ADDENDUM NO. 1

BARNEY POND DAM – PEDESTRIAN BRIDGE RFP 2013-22 JUNE 3, 2013

NOTICE TO PROSPECTIVE BIDDERS

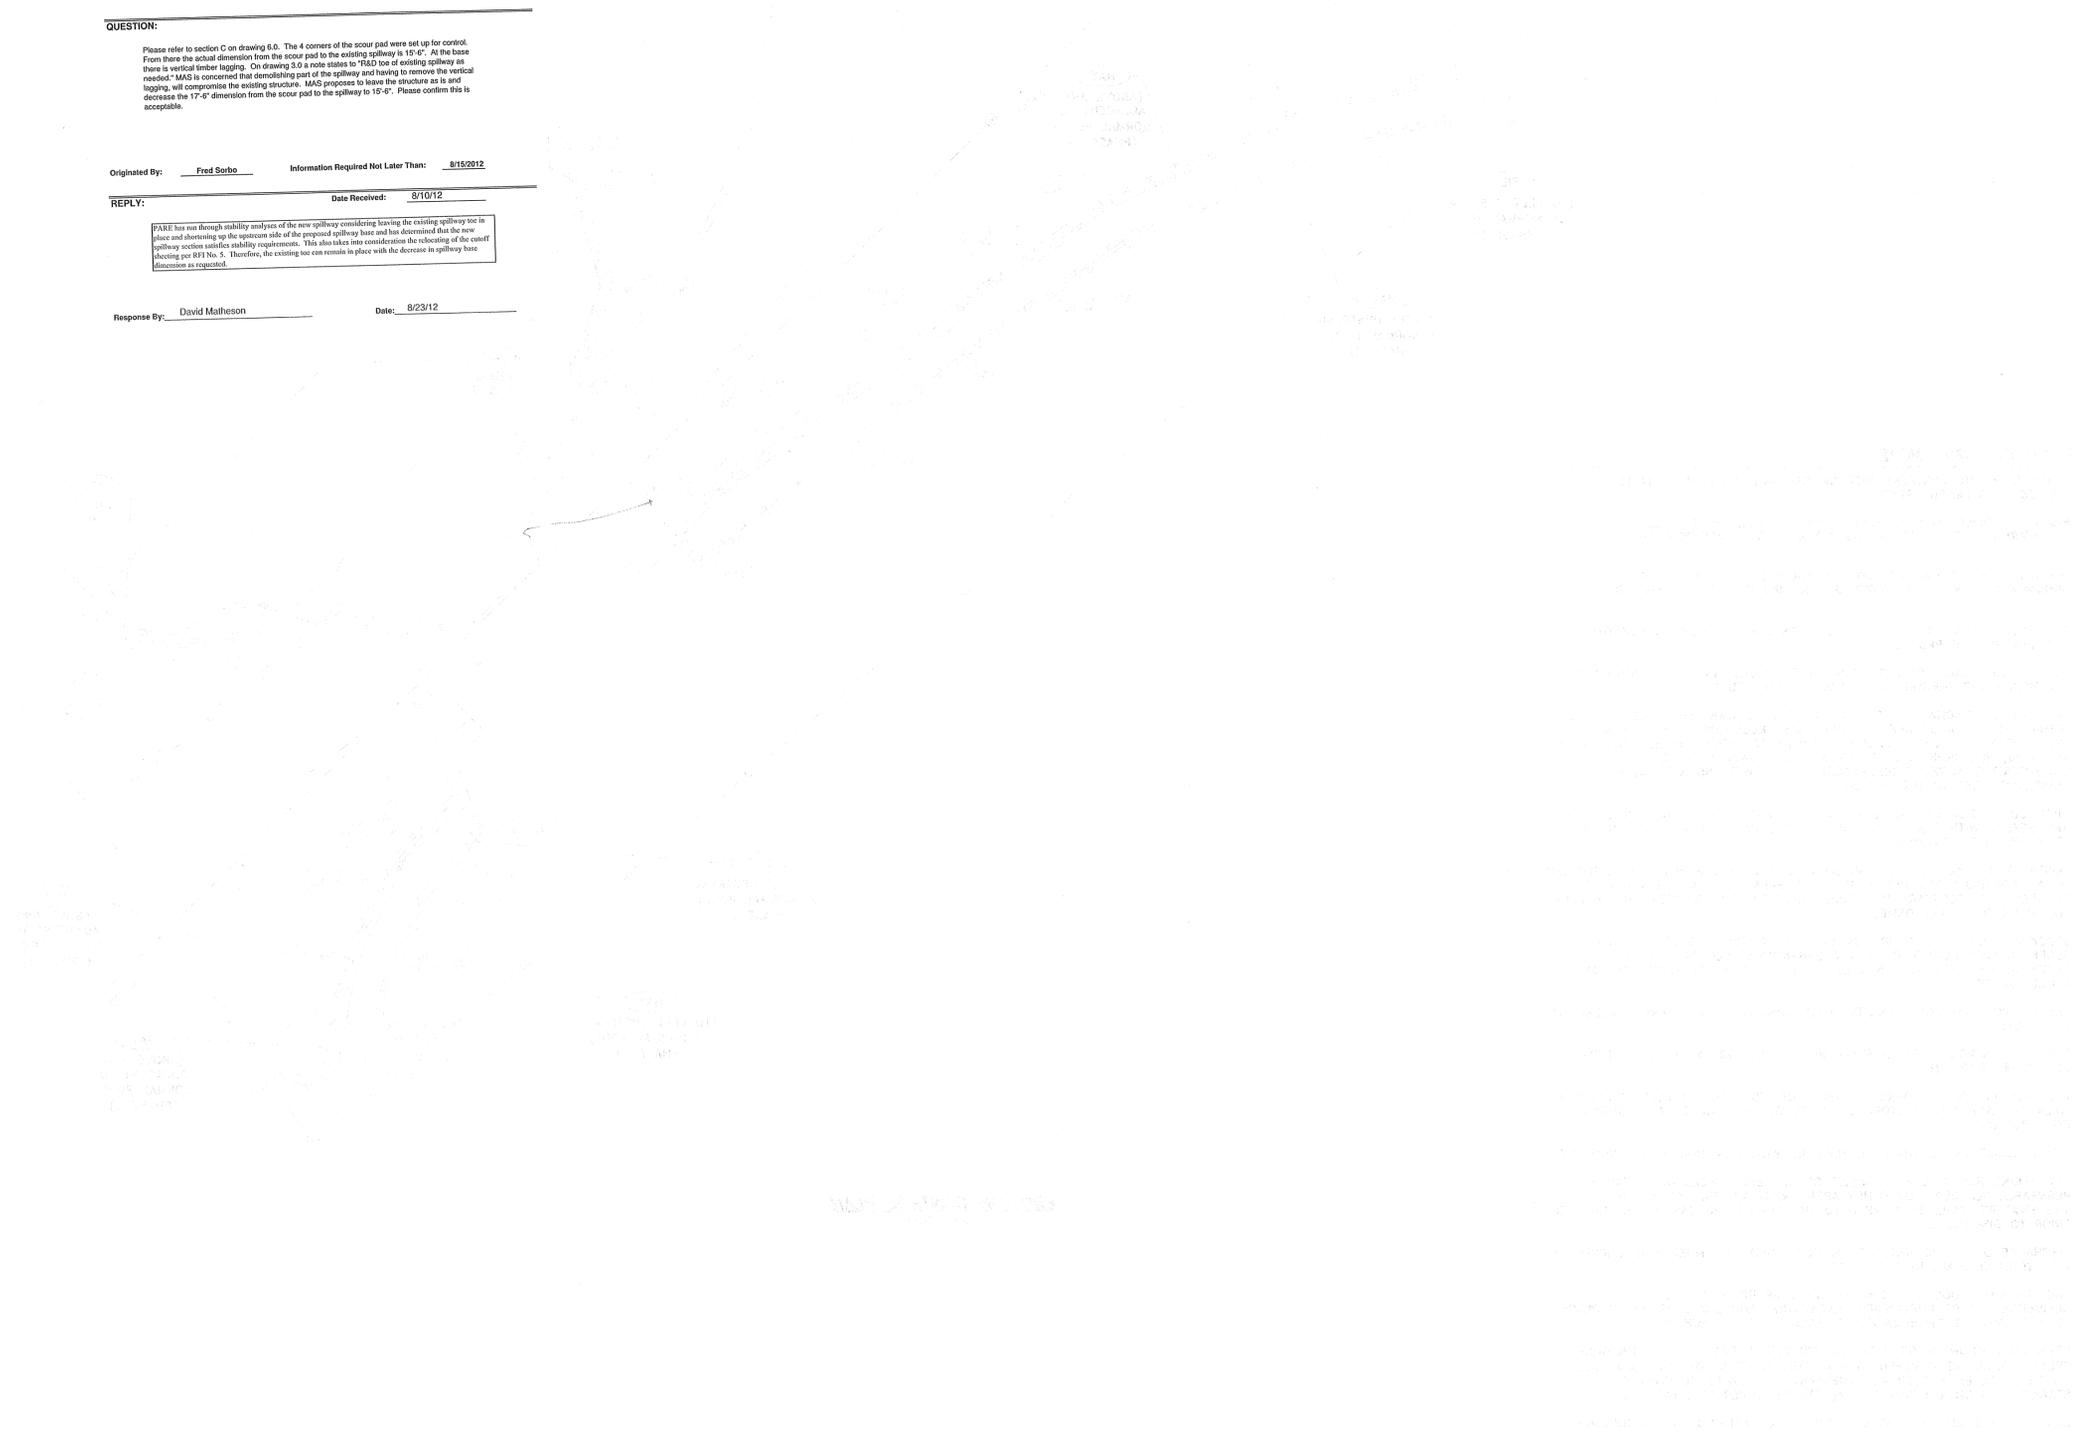
Please refer to section C on drawing 8.0. The 4 corners of the scour pad were set up for control. From there the actual dimension from the scour pad to the existing spillway is 15'-6". At the base there is vertical timber lagging. On drawing 3.0 a note states to "R&D look at existing spillway as needed." MAS is concerned that demolishing part of the spillway and having to remove the vertical lagging, will compromise the existing structure. MAS proposes to leave the structure as is and decrease the 17'-6" dimension from the scour pad to the spillway to 15'-6". Please confirm this is acceptable.

[ARE has run through stability analyses of the new spillway considering leaving the existing spillway in place and abutting up the upstream side of the proposed spillway base and has determined that the new spillway section satisfies stability requirements. This also takes into consideration the relocating of the cutoff floating per RFI No. 5. Therefore, the existing we can remain in place with the decrease in spillway base dimension as requested.

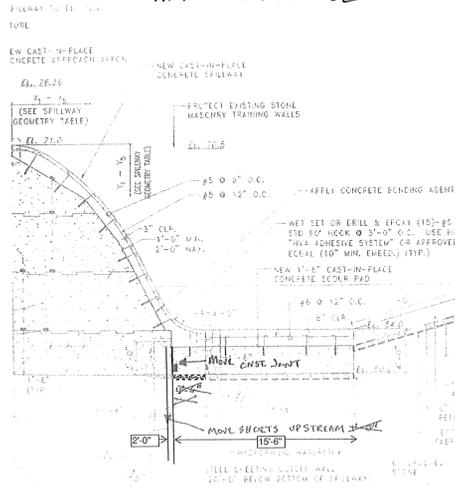
Please refer to section C on drawing 6.0. The 4 corners of the scour pad were set up for control. From there the actual dimension from the scour pad to the existing spillway is 15'-6". At the base there is vertical timber lagging. On drawing 3.0 a note states to "R&D toe of existing spillway as needed." MAS is concerned that demolishing part of the spillway and having to remove the vertical lagging will compromise the existing structure. MAS proposes to leave the structure as is and decrease the 17'-6" dimension from the scour pad to the spillway to 15'-6". Please confirm this is acceptable.

PAVE has run through stability analyses of the new spillway considering leaving the existing spillway toe in place and shortening up the upstream side of the proposed spillway base and has determined that the new spillway section satisfies stability requirements. This also takes into consideration the relocating of the cutoff sheeting per RFI No. 5. Therefore, the existing toe can remain in place with the decrease in spillway base dimension as requested.

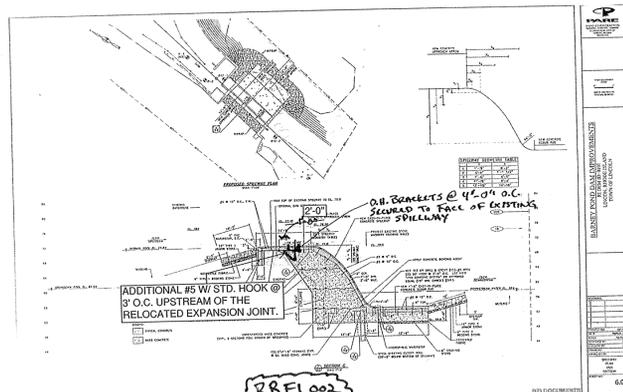
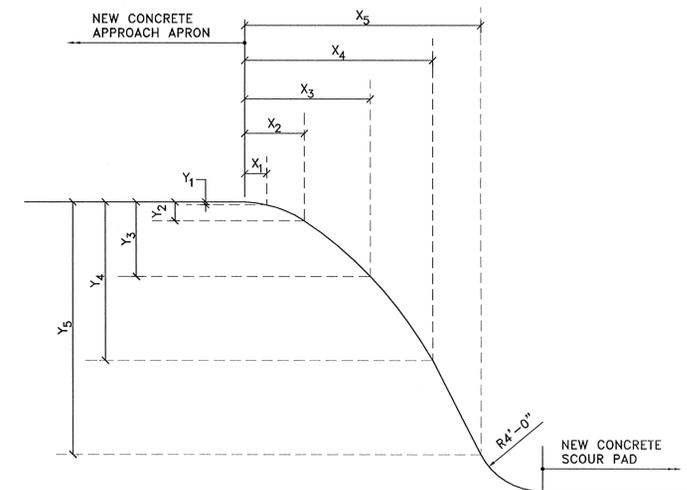
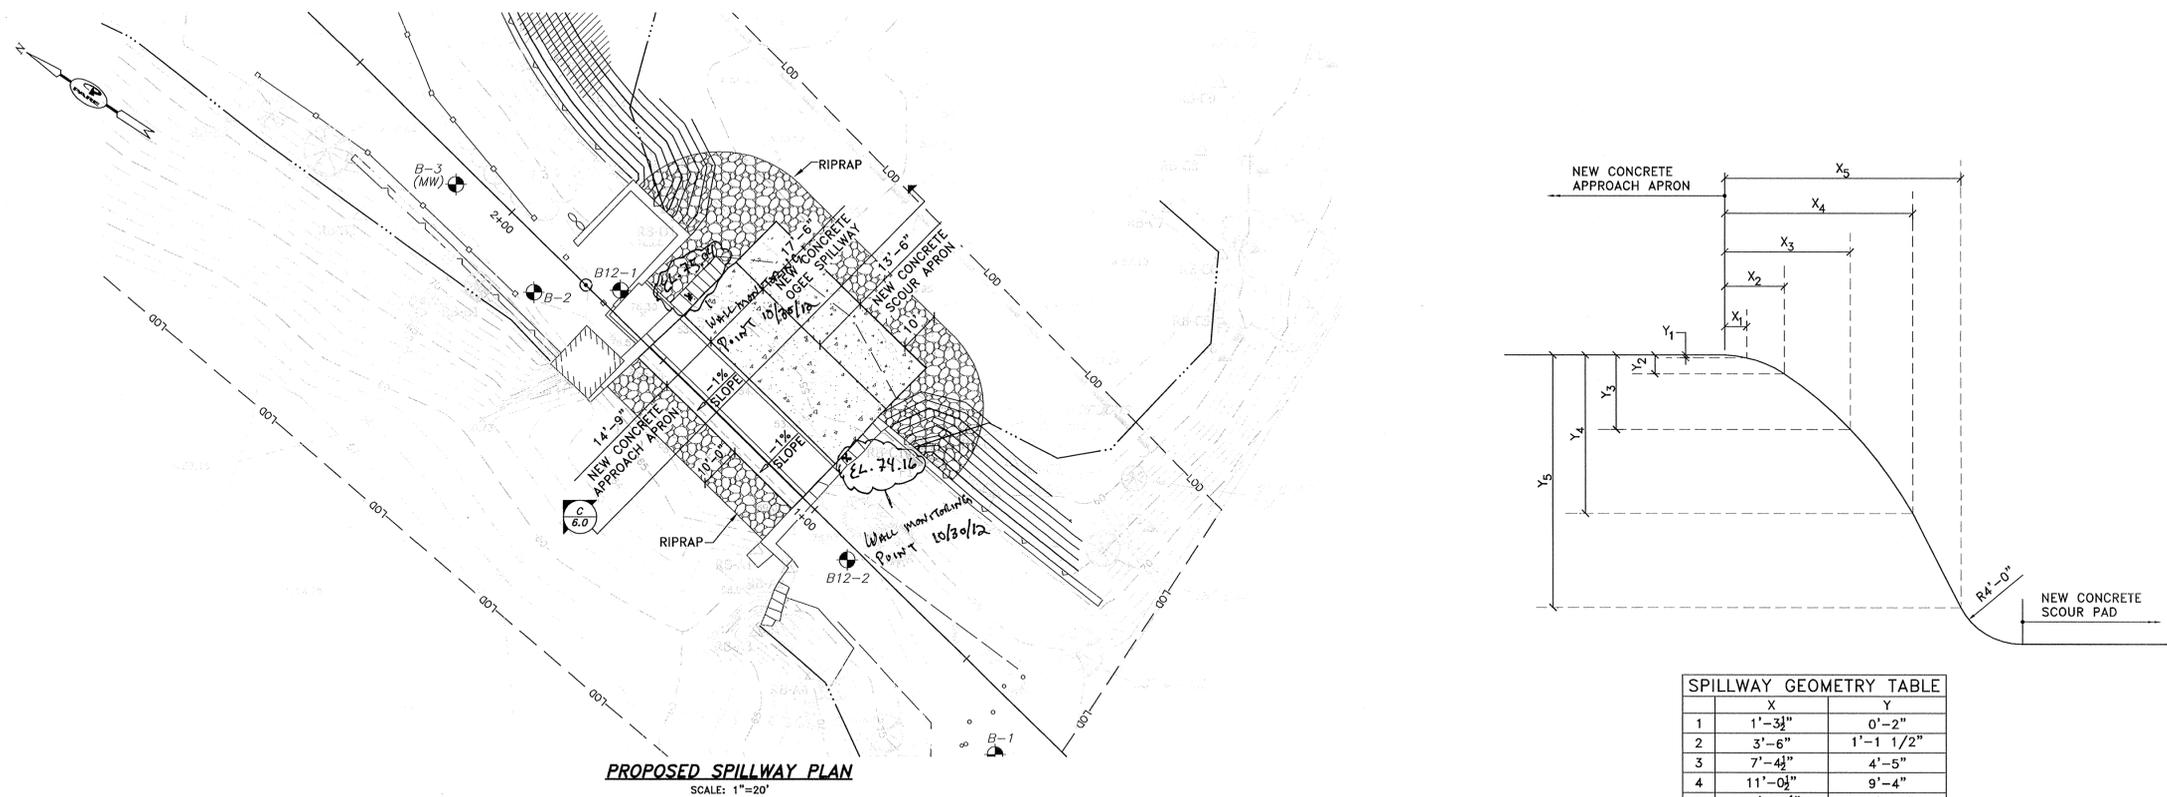
Please refer to Section C on Sheet 6.0 and the attached sketch. MAS proposes to move the expansion joint at the crest of the spillway back up the apron to 1'-0" before the crest of the existing spillway. MAS would also like to remove the construction joint at the top of the apron and pour the apron and the 4'-0" foundation wall monolithically. MAS will use the following steps for this procedure: 1) Apply bond breaker to existing spillway. 2) Install overhangs on existing spillway at 4'-0" on center for 1'-0" overhang. 3) The overhang will remain and not be removed until MAS forms the top lift of unreinforced concrete. Once the overhangs are removed the bond breaker will be repaired. Please confirm this is acceptable.

The alternative approach is acceptable given the following:
1. The expansion joint is relocated providing a minimum bearing of 2'-0" on the mass concrete, as indicated on the attached sketch.
2. An additional #5 hooked bar @ 3'-0" O.C. is provided upstream of the relocated expansion joint, as indicated on the attached sketch.

SHEET NO.: 6.0

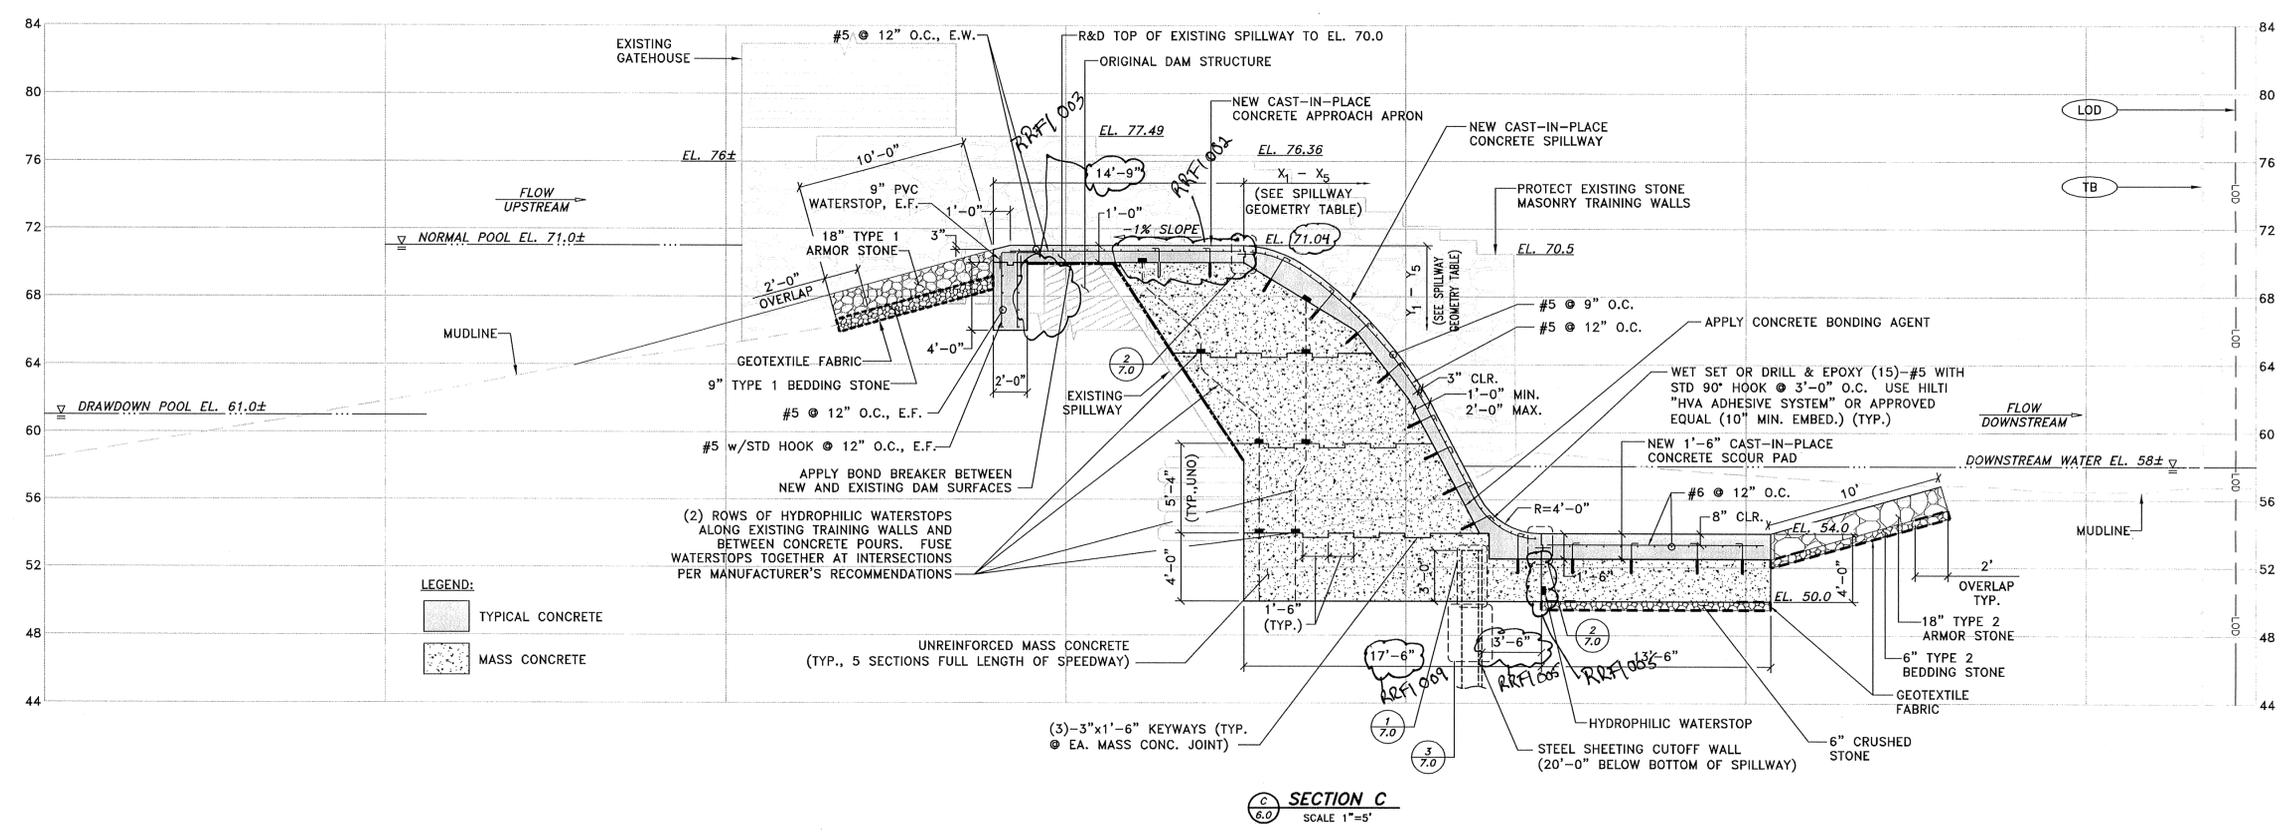
Please refer to Section C on Sheet 6.0. MAS laid out the upstream apron and noticed an issue. The original dam structure is in conflict with the new 4'-0" x 2'-0" foundation wall. All but 6" of the width of the wall will land on the original dam structure. MAS would like to move the wall and apron upstream. Please advise.

Please refer to section C on drawing 6.0 and the attached sketch. MAS would like to move the vertical construction joint in the first lift of unreinforced concrete. The joint would be moved from the downstream separation joint to relieve the height of the concrete jumps from 2'-0" to 4'-0". This is for constructability purposes, moving the joint would make the forming more efficient. Also, MAS would propose moving the steel sheeting cutoff wall 1'-0" upstream, in order to keep it away from the joint. Please confirm this is acceptable.

The proposed upstream vertical wall may be constructed immediately upstream of the existing upstream face of the spillway. A bond breaker shall be provided as indicated on the plans and the reinforcing steel shall be adjusted accordingly. The proposed spillway apron shall be elongated in the upstream direction to accommodate this change. The configuration of the downstream side of the spillway shall remain the same.

The joint can be shifted as requested with modifications to the RFI as follows:
1. Extend the bedding stone layer to the relocated joint as indicated on the marked up sketch (See Attached).
2. Relocate the cutoff sheeting such that the downstream face is 2 feet upstream of the relocated joint as indicated on the marked up sketch (See Attached).
